IMPORTANT — To assure product **SAFETY** and **RELIABILITY**, repairs, maintenance or adjustments should be performed by **MAKITA** Service Centers or other qualified service organizations. Always use **MAKITA** replacement parts.

SERVICE CHANGE

1. Changes on Shear Blade.

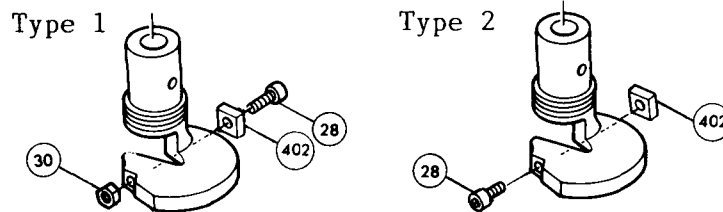
Fig. 402 is threaded.

Fig.	Description	Type 1	Type 2
28	Hex Socket Head Bolt	Part #922137-2 (Size:M4x20)	Part #922127-5 (Size:M4x16)
30	Hex Nut	Part #252036-7	—————
402	Shear Blade	Part #191384-8 (Discontinued)	Part #191384-8A

The above parts are completely interchangeable as a set.

2. Change on Motor Housing

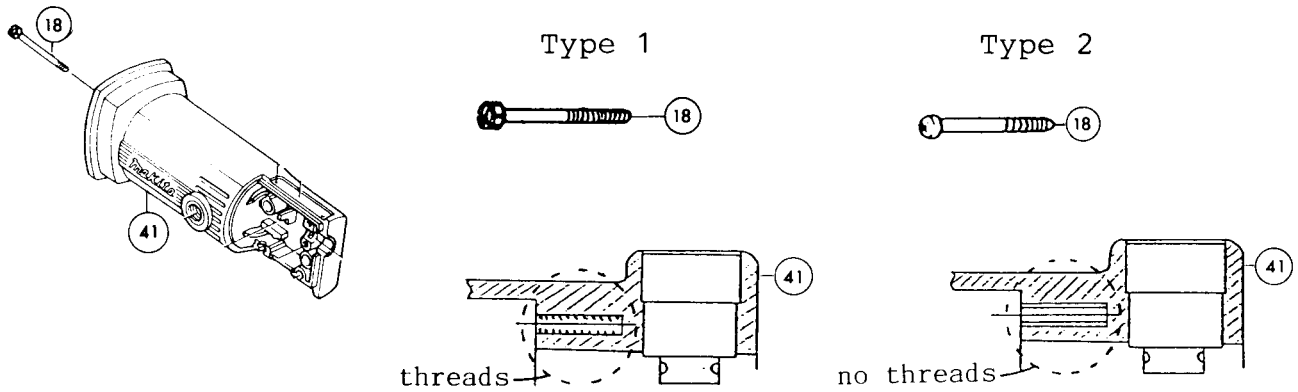
Fig.	Description	Type 1	Type 2
18	_____	Part #925183-4 Hex Bolt M4x55	Part #265891-8 Tap Screw M4x55
41	Motor Housing	Part #156766-1 (Discontinued)	Part #157720-8

The above parts are completely interchangeable as a set.
